Project	IEEE 802.16 Broadband Wireless Access Working Group < http://ieee802.org/16 >	
Title	Open loop power control for uplink	
Date Submitted	2004-09-02	
Source(s)	<p>Panyuh Joo, Seungjoo Maeng, Jaeho Jeon, Soonyoung Yoon, Jeong-Heon Kim, Jaehyok Lee, Myungkwang Byun, Inseok Hwang, Jaehee Cho, Jiho Jang, Sanghoon Sung, Hoon Huh, janghoon yang, ByoungHa Yi Samsung Electronics Co. Ltd.</p> <p>Choongil Yeh, Hyoungsoo Lim, Yuro Lee, Jongee Oh, DongSeung Kwon, ETRI</p> <p>Yuval Lomnitz Intel</p> <p>Ran Yaniv, Naftali Chayat Alvarion</p> <p>Yigal Leiba</p> <p>Runcom</p>	<p>panyuh@samsung.com</p> <p>lim@etri.re.kr</p> <p>yuvall@envara.com</p> <p>ran.yaniv@alvarion.com</p> <p>yigall@runcom.com</p>
Re:	Recirculation of P802.16 REVe/D4	
Abstract	<p>Open loop power control operation is proposed to determine uplink transmit power</p> <p>The simulation results are added.</p>	
Purpose	Adoption of suggested changes into P802.16e/D5

Figure ddd - Bandwidth request and UL Tx power report header format

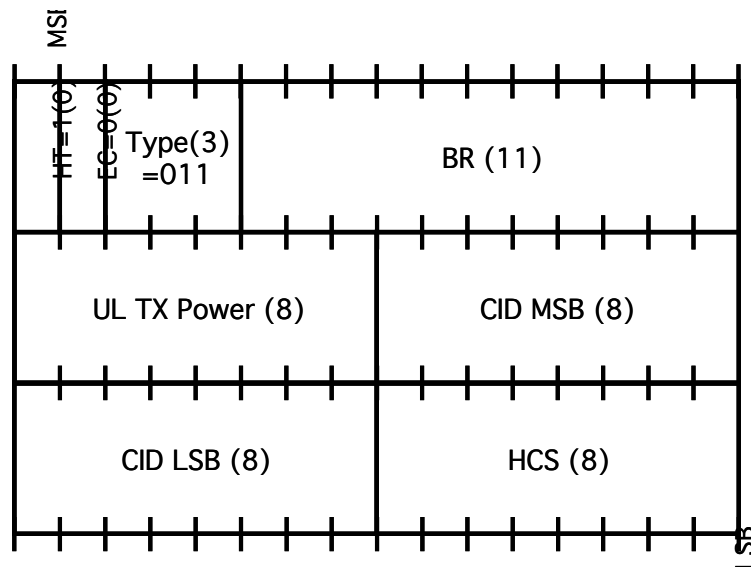
[Add the following subclause at the end of 6.3.2.1.3 “PHY channel report header”]

6.3.2.1.4 Bandwidth request and UL Tx power report header

The Bandwidth Request and UL Tx power report PDU shall consist of bandwidth request and UL Tx power report header alone and shall not contain a payload. The bandwidth request and UL Tx power report header is illustrated in Figure ddd.

The The bandwidth request and UL Tx power report header shall have the following properties:

- a) The length of the header shall always be 6 bytes.
- b) The EC field shall be set to 0, indicating no encryption.
- c) The CID shall indicate the SS basic CID.
- d) The TYPE field should be “011”.
